Wrightstown Sanitary District #1
- Greenleaf Ammonia Sample Results -
By Mary Gansberg
Department of Natural Resources

Subject: Ammonia Limits at Greenleaf

Subject: NH₃-N Limits At Greenleaf - Wrightstown Sanitary District #1

(Total Ammonia vs Temperature at various pH values)
 Ammonia Toxicity - Warm Water Fishery (Chart #1)

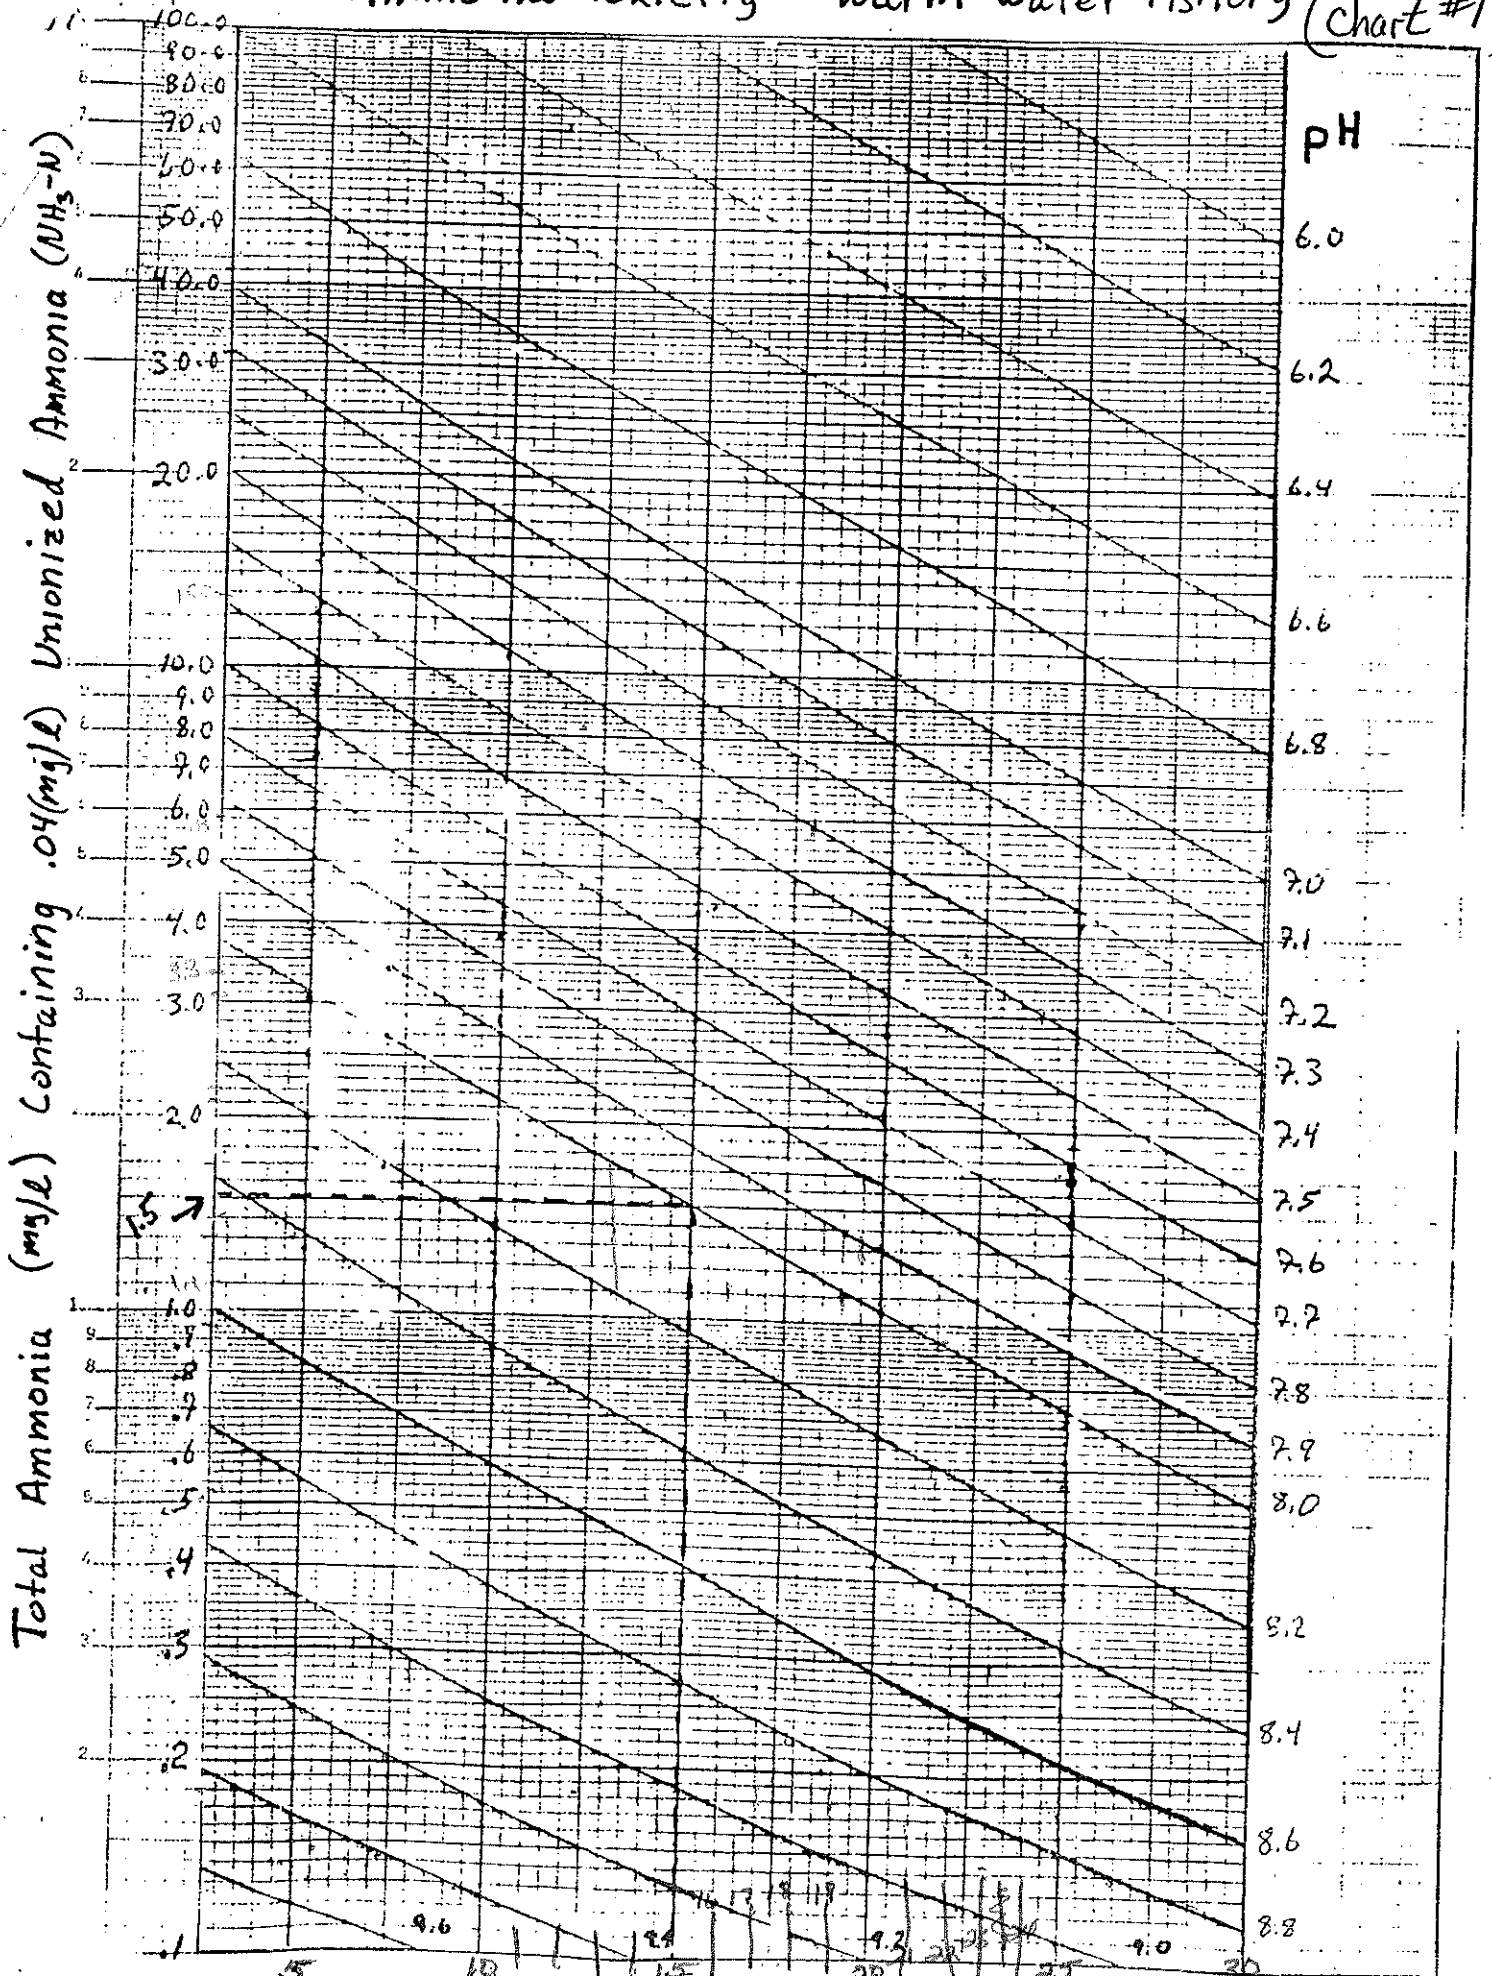
Third, we can determine the maximum or critical concentration ammonia-nitrogen can be at a specific pH and temperature before it becomes toxic to fish and aquatic life. (See chart #1). The principle toxicity problem is from ammonia in the molecular form (NH₃) which can adversely affect fish life in receiving waters. A slight increase in pH may cause a great increase in toxicity as the

ammonia ion (NH_4^+) is transformed to ammonia. These values were determined for the receiving water. The data shows the ammonia concentrations were always below the critical toxicity level in the upstream site (GL-2) but were over the toxic level two different times in the downstream site (GL-3). Again, this shows that the sewage treatment plant effluent is significantly increasing the ammonia levels of the receiving water to a concentration that is greater than the toxic limit.

DIAGRAM A

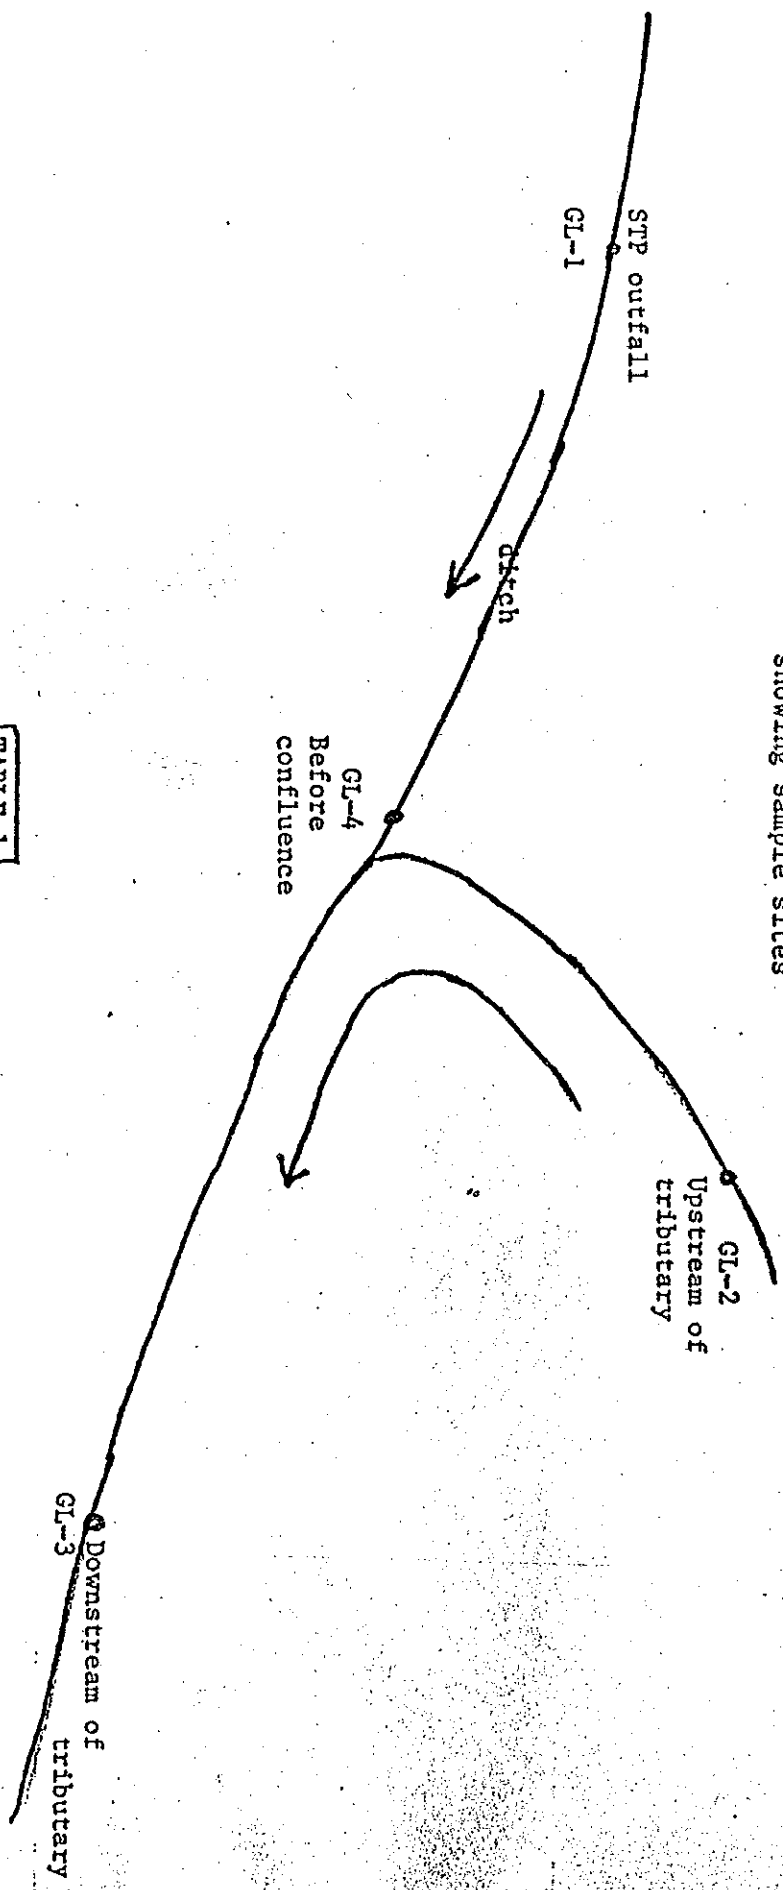
First, we can compare the ammonia concentration at the outfall (GL-1) to the ammonia concentration of the effluent at the end of the ditch (GL-4). (See Table 1 and Diagram A). On one occasion there was no change. The ammonia concentration from GL-1 to GL-4 remained equal. On two other occasions there was only a slight decrease in ammonia from GL-1 to GL-4. And on one occasion a considerable decrease in ammonia concentration from the outfall to the end of the effluent ditch occurred. This suggests that under these conditions the distance of the ditch is not long enough to significantly decrease the ammonia concentration.
